1994 Texas Accessibility Standards *Technical Memorandum*

Texas Department of Licensing and Regulation Architectural Barriers

TM 99-11

Curb Ramps – Sides of Curb Ramps 4.7.5

Fig. 59

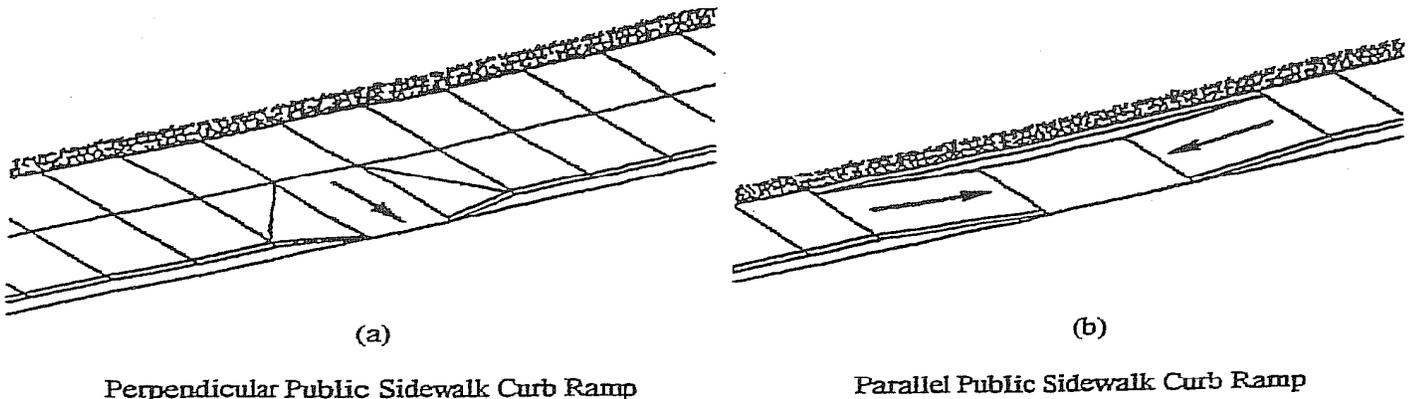
Since 4.7.5 of TAS states that, “If a curb ramp is located where a pedestrian must walk across the ramp, or where it is not protected by handrails or guardrails, it shall have flared sides”, this department has not accepted parallel type curb ramps (as shown in proposed Section 14, Figure 59(b) of ADAAG) except through an approved variance. However, our position is to allow the use of these types of ramps without a variance.

This issue was discussed with various disability advocacy groups, and none felt that this design posed any significant hazard to any persons with disabilities. The matter was then submitted to the Architectural Barriers Advisory Committee for consideration. The committee recommended accepting these types of ramps without a variance, as they, too, did not consider them a hazard. Further, they felt that since this design appeared in proposed ADA Accessibility Guidelines (although limited to public rights-of-way, where right-of-way width will not accommodate a perpendicular curb ramp and landing), that accepting this design would not pose a problem. However, we strongly recommend maintaining slopes of 5.0% or less for this design so that these will not be considered “curb ramps”. Otherwise, the curb ramp must comply with all of TAS 4.7.

This position applies to new construction as well as alterations.
